31 May 2023

Job No. 21-13556

Subject: **Addendum to the Report of Preliminary Geotechnical Investigation and Geologic Fault Investigation and Response to the City of San Diego Geotechnical Review**
Proposed Javaheri Residence
2072 Via Casa Alta
La Jolla, California

7/22/2022 3:09:10 PM

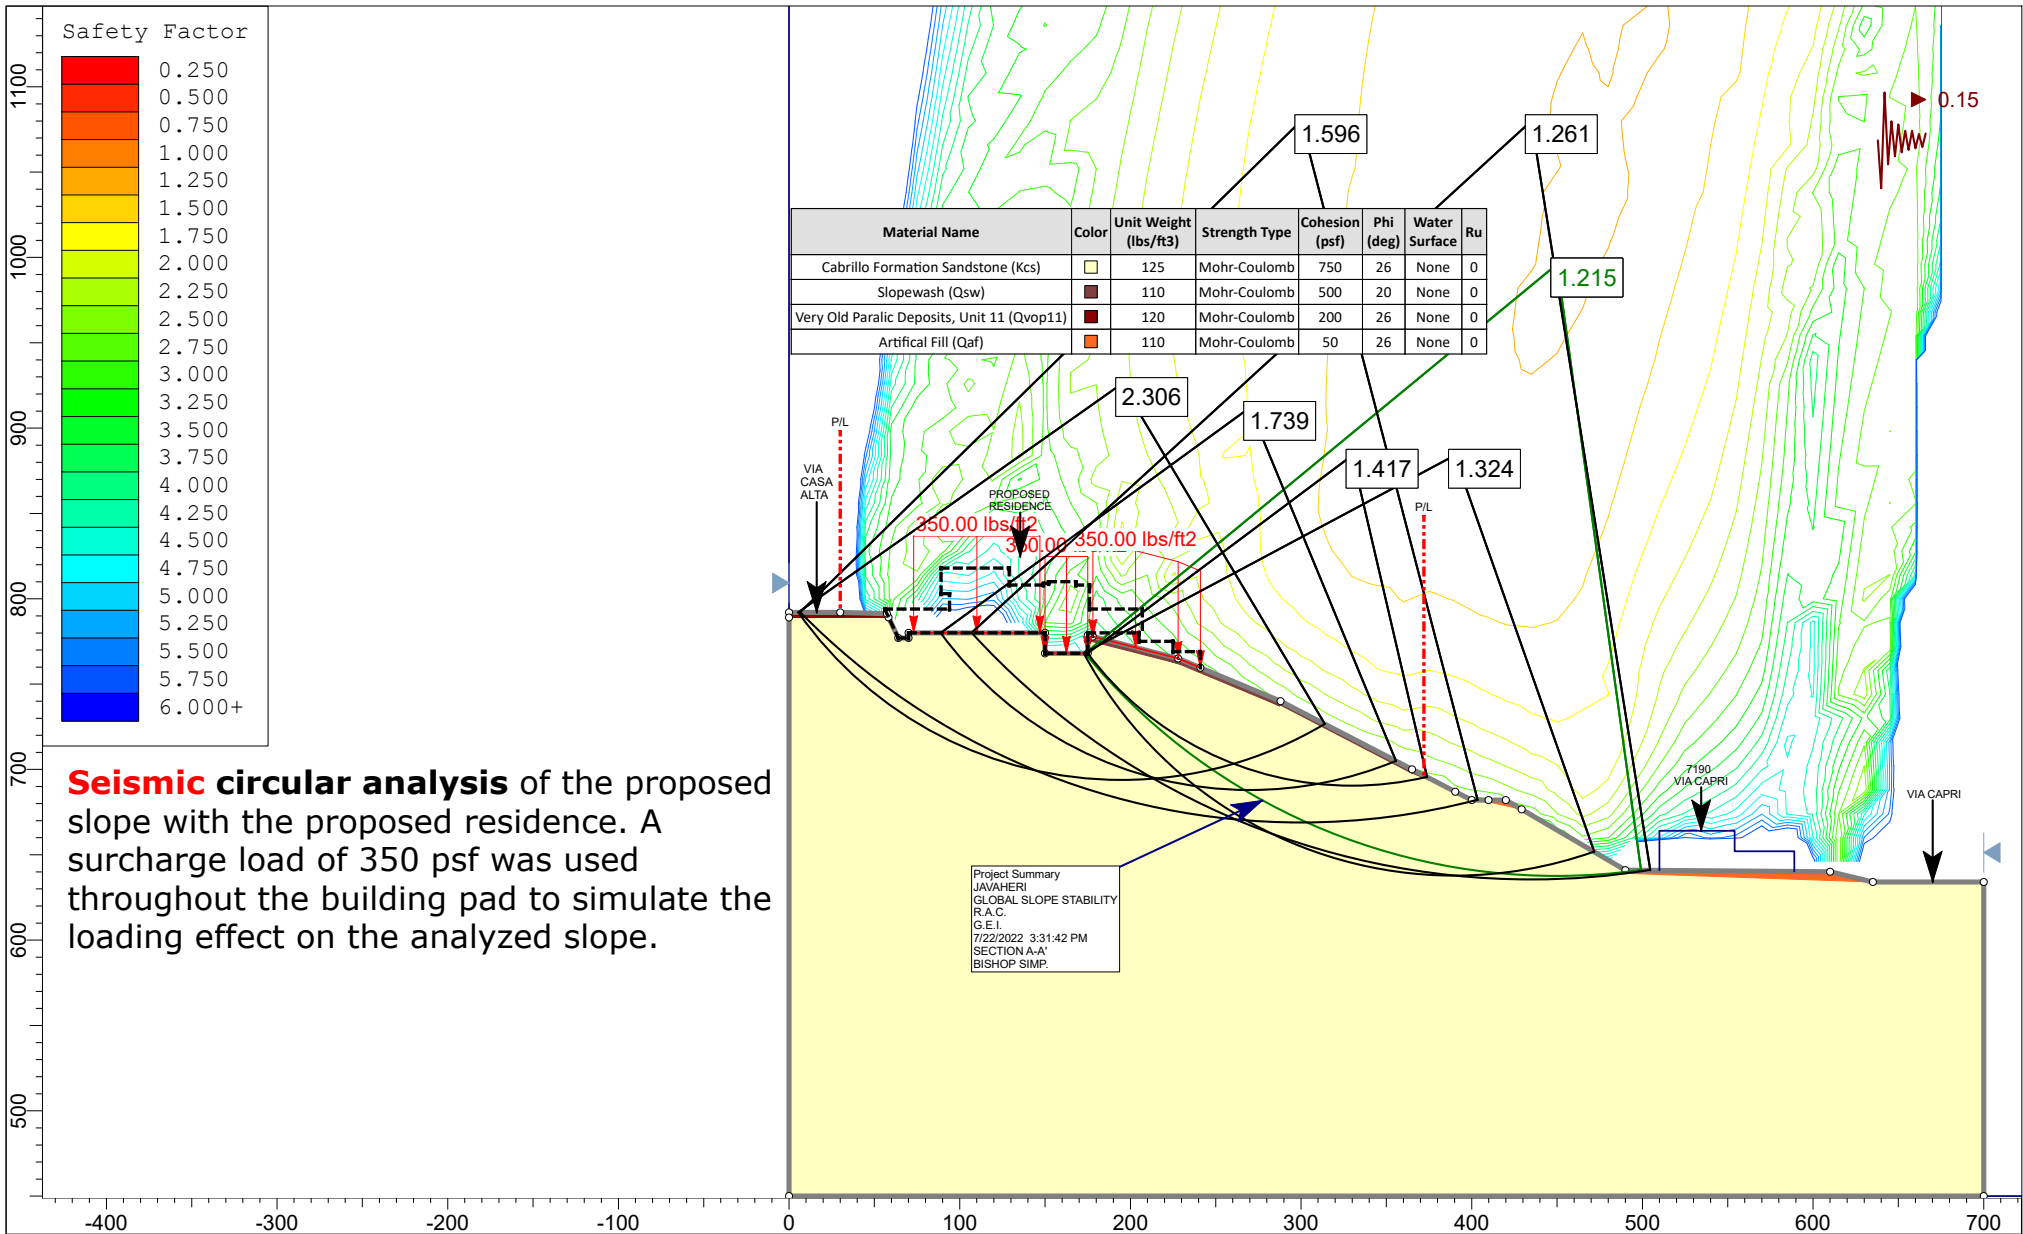
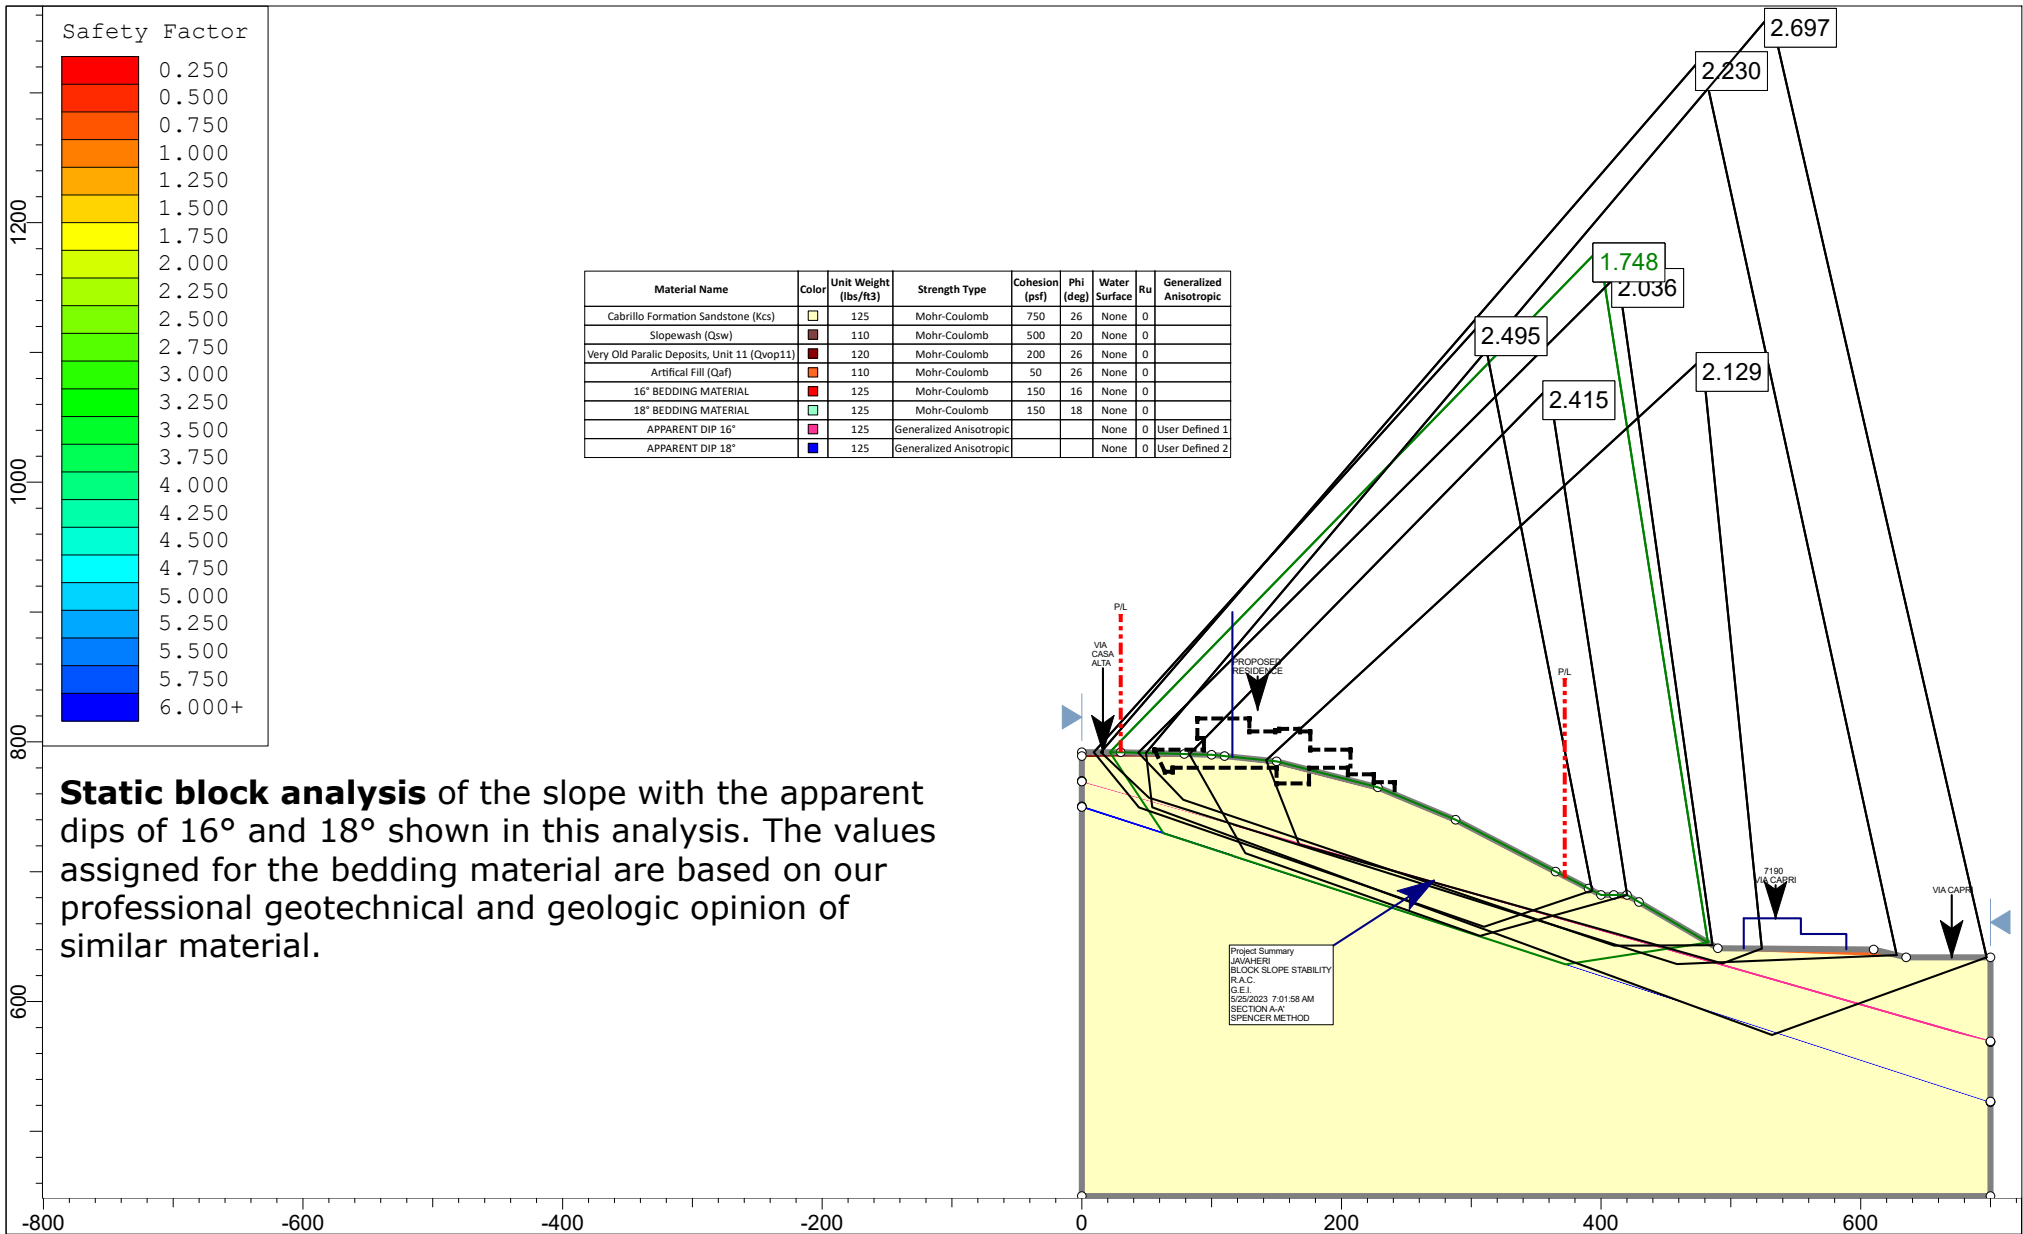
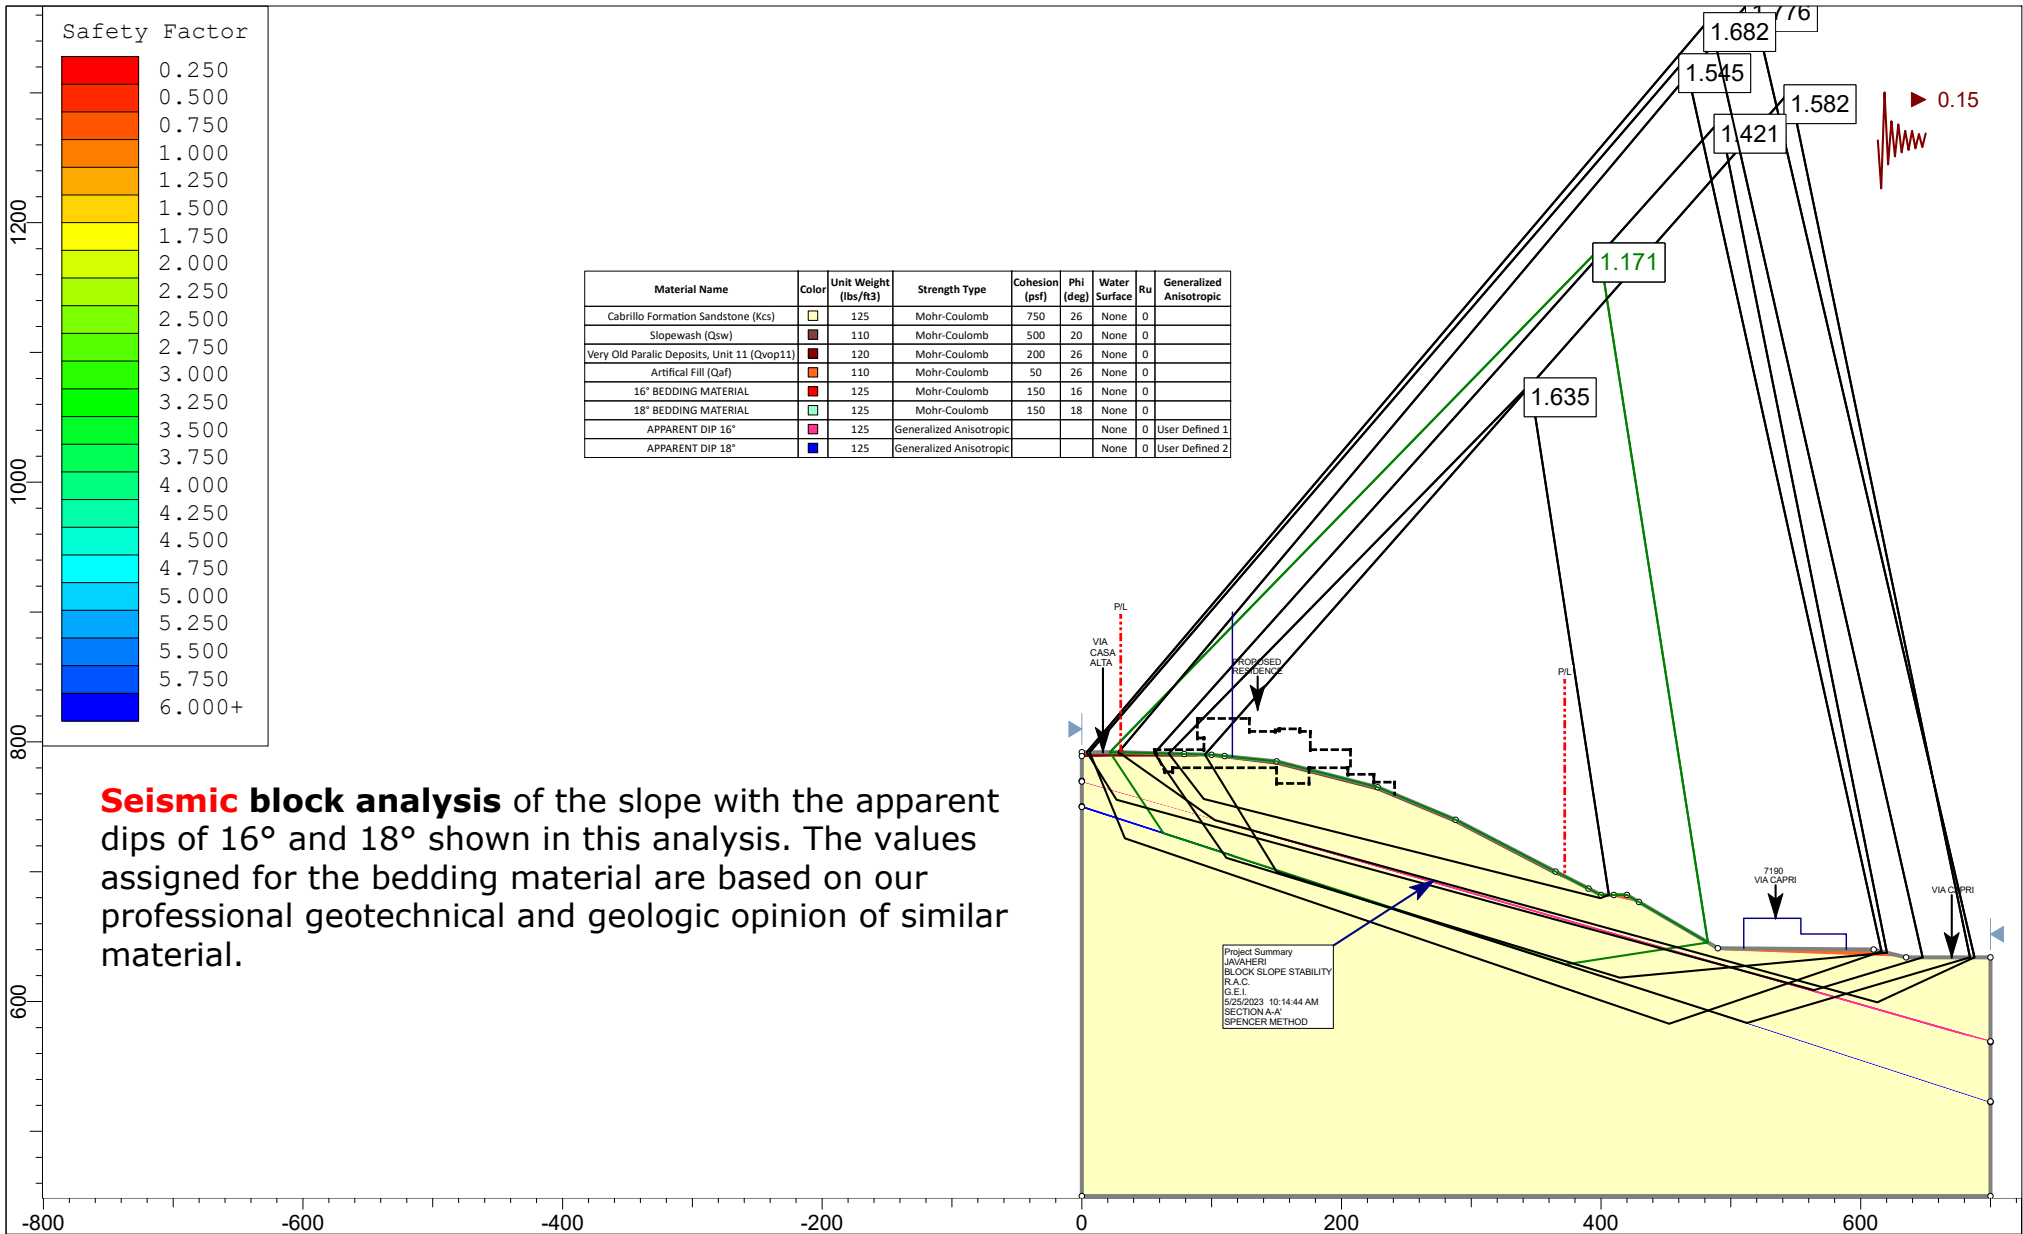
Issue No. 24: *The project's geotechnical consultant should clarify if their stability analysis presented in the submitted report included site-specific bedding and geologic structure data. As per the City's Guidelines for Geotechnical Reports, describe the stability analysis and discuss the results. The description should include the method of analysis, specified material profile, and specified search areas for critical failure paths. Where multiple slope stability analyses are conducted, a tabulated summary of the analyses and results should be provided. (New Issue)*

Response: The slope stability analysis, presented here as Appendix A, includes site-specific bedding and geologic structure data as well as the method of analysis, specified material profile, and specified search areas for critical failure paths. A tabulated summary of the analyses and results is also provided in Appendix A.

Analysis No.	Method-Type	Condition	Lowest FOS
S(A)_01	Bishop-Circular	Static	1.715
S(A)_01w_0.15g	Bishop-Circular	Seismic	1.224
S(A)_02	Bishop-Circular	Static	1.686
S(A)_02w_0.15g	Bishop-Circular	Seismic	1.215
S(A)_03	Spencer-Block	Static	1.748
S(A)_03w_0.15g	Spencer-Block	Seismic	1.171
S(A)_04	Spencer-Block	Static	1.781
S(A)_04w_0.15g	Spencer-Block	Seismic	1.279
S(A)_05	Spencer-Block	Static	1.842
S(A)_05w_0.15g	Spencer-Block	Seismic	1.295
